UNEP/OzL.Pro/ExCom/66/51

تكاليف إضافية تتعلق بإعادة تجهيز الأدوات من أجل تصنيع
المبدلات الحرارية (المقرران 45/61 و61/62)

**A STUDY OF FIN AND TUBE COIL MANUFACTURING CHANGES FOR CONVERSION
FROM R-22 TO R-410A**

ATTACHMENT III

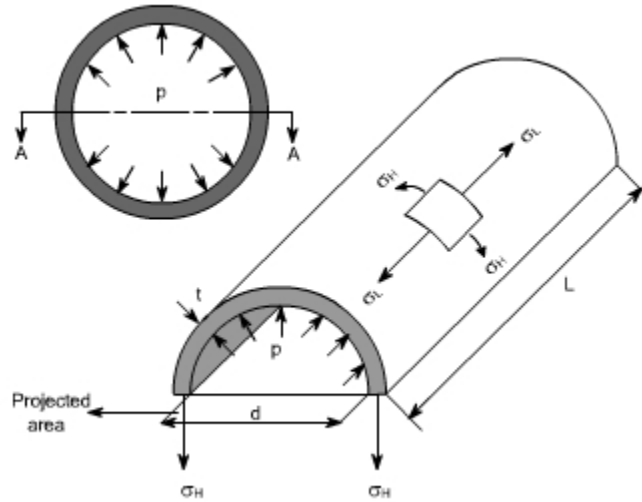
However, the pressure of R-410A system is nominally 60% to 70% higher than R-22, thus the R-410A coil must be redesigned in order to meet the burst test pressure. The paper claims that designing coils for R-410A to meet the burst test pressure would require the wall thickness to be 70% higher since the tube wall thickness increase proportionately with pressure. This would require additional copper and would be very costly.

The paper then suggests using a fatigue test as an alternative method to qualify R-410A coils without changing the tube diameter, thickness, nor the standard materials of construction.

WB comments:

1. While we agree that fatigue test is a good method to test the system under simulated normal operating condition, we do not think it adequately addresses the above condition that could occur during shipment. If coils cannot withstand the typical burst test pressures needed to qualify R-410A coils, the recommendation should have been to find an engineering solution to solve the problem, instead of changing a testing method. Extending the result of the fatigue test analysis to
